CENTRAL COAST COUNCIL

DEVELOPMENT SUPPORT SPECIAL COMMITTEE

6.1 Residential (dwelling extensions, carport and outbuilding – shed) – variations to rear boundary setback standards, side boundary development standards, setback of a carport from frontage boundary, building envelope standards for dwelling, carport and shed, and total site coverage at 2 King Edward Street, Ulverstone – Application No. DA215181

<i>‘DEVELOPMENT APPLICATION No.:</i>	DA215181
<i>PROPOSAL:</i>	Residential (dwelling extensions, carport and outbuilding – shed) – variations to rear boundary setback standards, side boundary development standards, setback of a carport from frontage boundary, building envelope standards for dwelling, carport and shed, and total site coverage
<i>APPLICANT:</i>	Jason Shephard
<i>LOCATION:</i>	2 King Edward Street, Ulverstone
<i>ZONE:</i>	General Residential
<i>PLANNING INSTRUMENT:</i>	<i>Central Coast Interim Planning Scheme 2013</i> (the Scheme)
<i>ADVERTISED:</i>	1 December 2016
<i>REPRESENTATIONS EXPIRY DATE:</i>	17 December 2016
<i>REPRESENTATIONS RECEIVED:</i>	Nil
<i>42-DAY EXPIRY DATE:</i>	10 January 2017 (extension of time until 23 January 2017)
<i>DECISION DUE:</i>	9 Janua

SITE PLAN

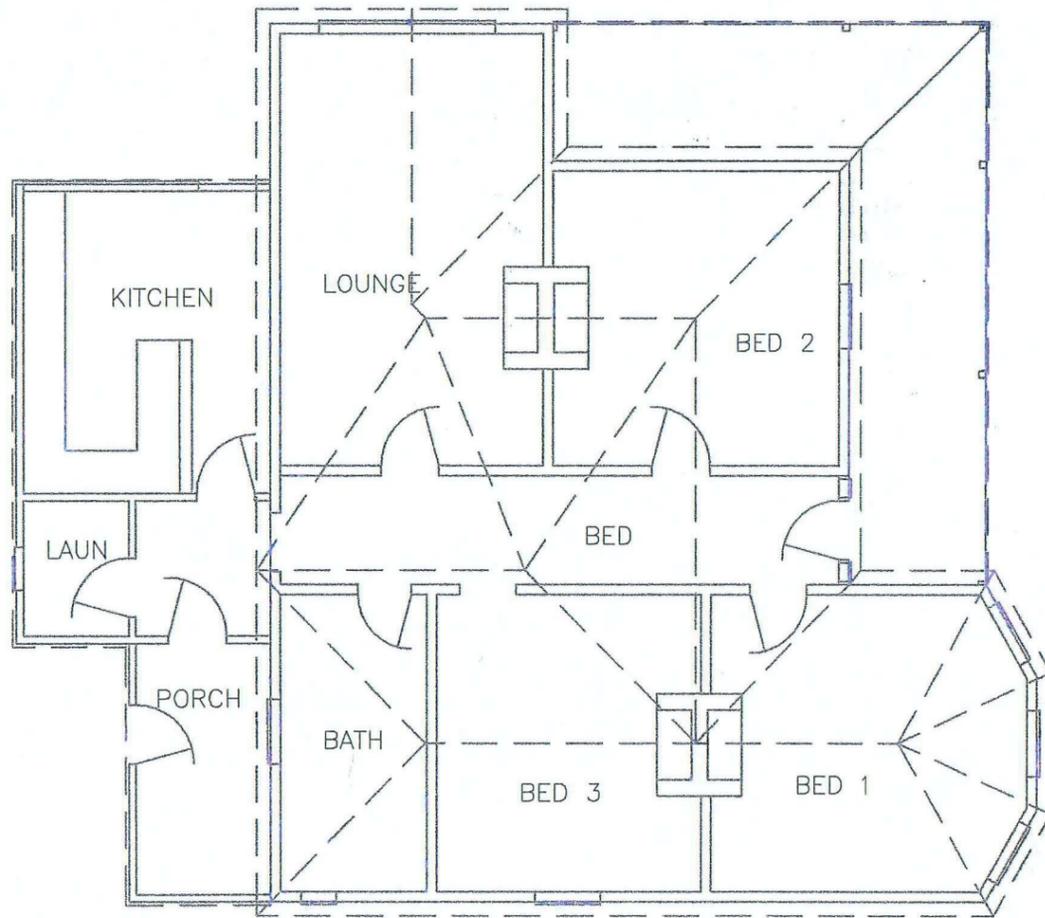
- R2 A new 3.6m wide access shall be located on the King Edward Street frontage generally as shown on the Yaxley Design & Drafting Site Plan, Drawing No. 216033-2 dated 2 October 2016 (copy enclosed);

SHADOW PLAN

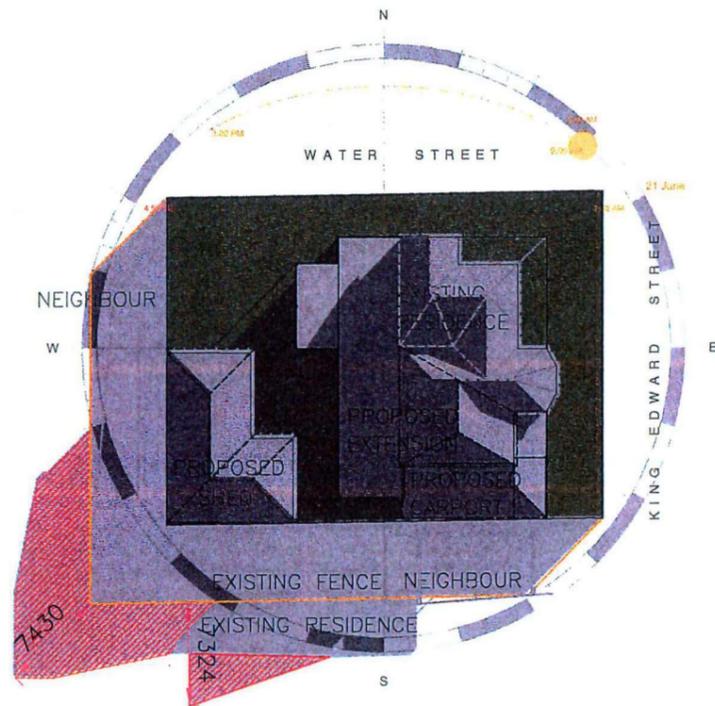
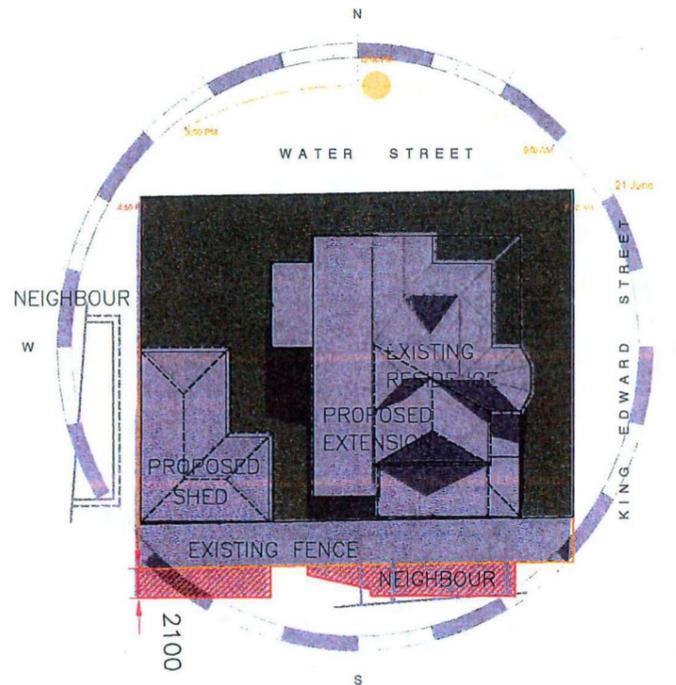
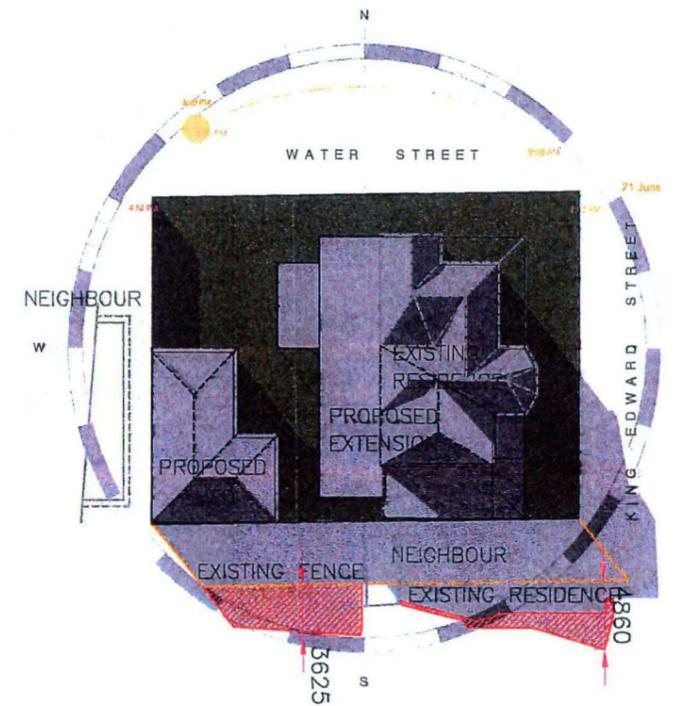
The application is accompanied by shadow pattern diagrams that demonstrate the shadow impact on adjoining property on 21 June at 9.00am, 12.00pm and 3.00pm. The shadow diagrams show that the adjoining property to the south, 4 King Edward Street, would receive sustained overshadowing for the whole of the day; from 9.00am to 3.00pm on 21 June, over and above shading by the boundary fence, shading north-facing habitable rooms and an area of north/west private open space.
